REQUEST:
RDM Electric - 3/21/13 RFI 289

NEW ELEMENTARY SCHOOL
9801 HIGHLAND KNOLLS DR
BAKERSFIELD
CALIFORNIA
93306

NEW MIDDLE SCHOOL
4115 VINELAND ROAD
BAKERSFIELD
CALIFORNIA
93306

SHEET TITLE
LIGHTING SITE PLAN

LIGHTING SITE PLAN

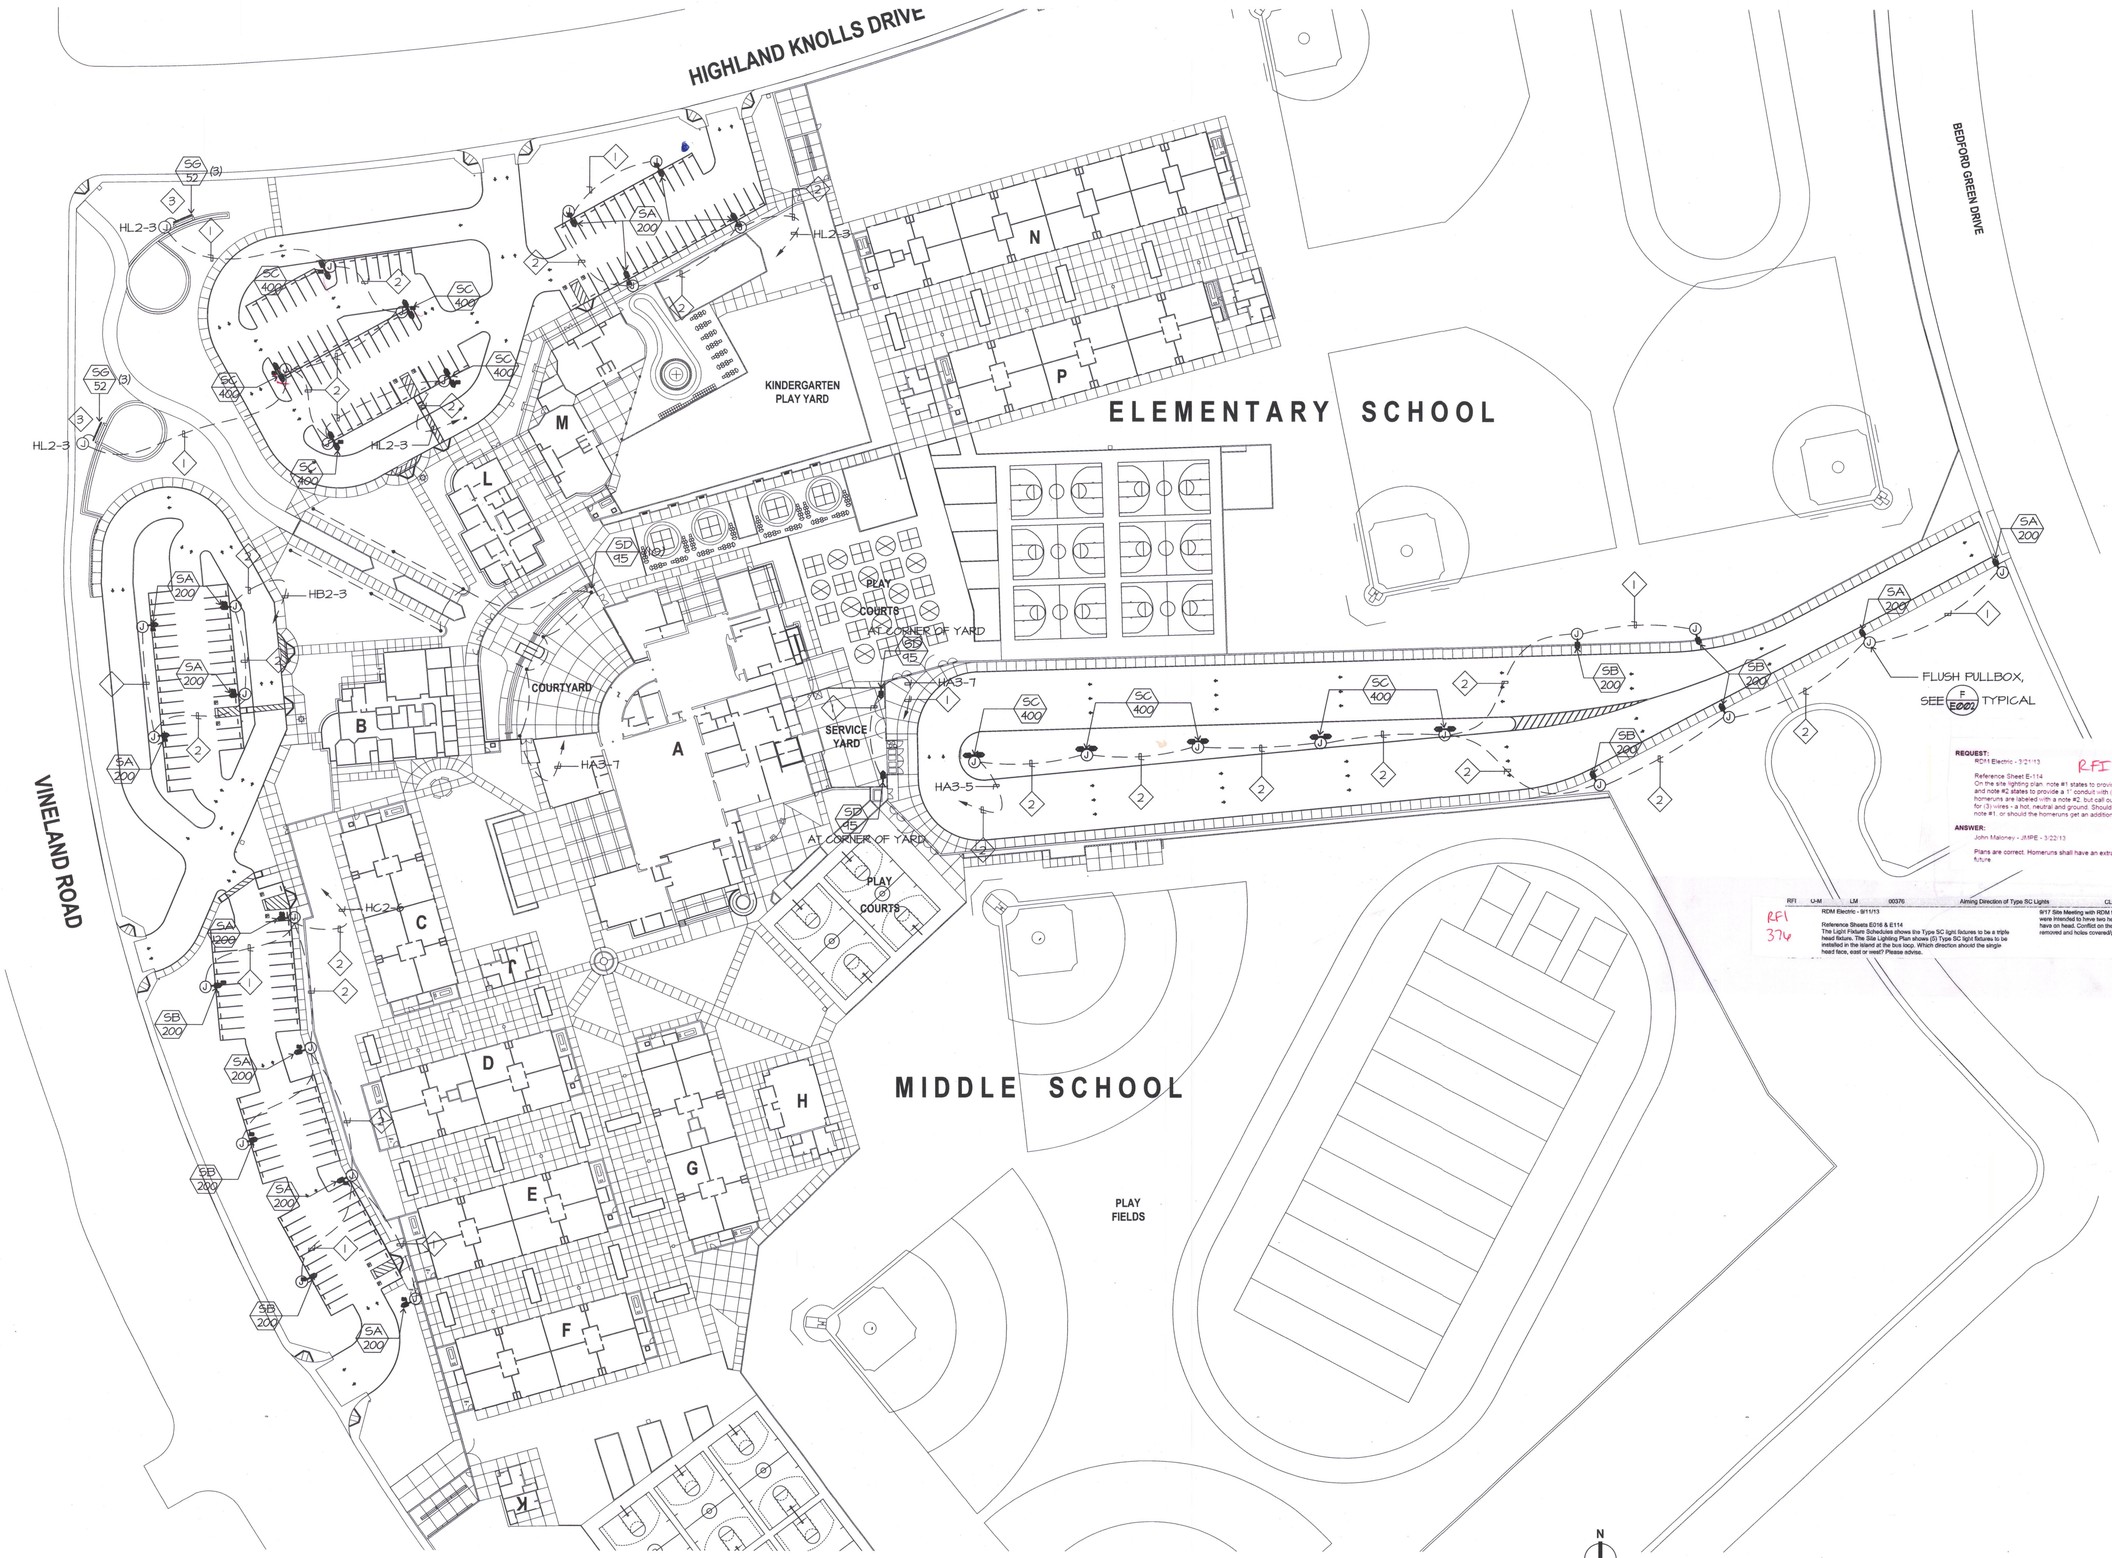
Reference Sheet E-114
On the site lighting plan, note #1 states to provide a 1" conduit with (2) #8 and (1) #10 ground and note #2 states to provide a 1" conduit with (3) #8 and (1) #10 ground. However, the homeruns are labeled with a note #2, but call out for only one circuit. One circuit only allows for (3) wires - a hot, neutral and ground. Should all the runs, including the homeruns, have a note #1, or should the homeruns get an additional circuit? Please advise.

RFI	U-M	LM	00376	Aiming Direction of Type SC Lights	CLO	5/11/2013	9/18/2013
RFI 376	RDM Electric - 5/11/13 Reference Sheets E016 & E114 The Light Fixture Schedules shows the Type SC light fixtures to be a triple head fixture. The Site Lighting Plan shows (5) Type SC light fixtures to be installed in the island at the bus loop. Which direction should the single head face, east or west? Please advise.						9/18 Site Meeting with RDM to determine fix for site lights. 3 headed fixtures were intended to have two heads, double headed fixtures were intended to have on head. Conflict on the fixture schedule. Additional fixtures will be removed and holes covered/patched on a T&M basis.

Plans are correct. Homeruns shall have an extra conductor for an extra circuit if desired in the future.
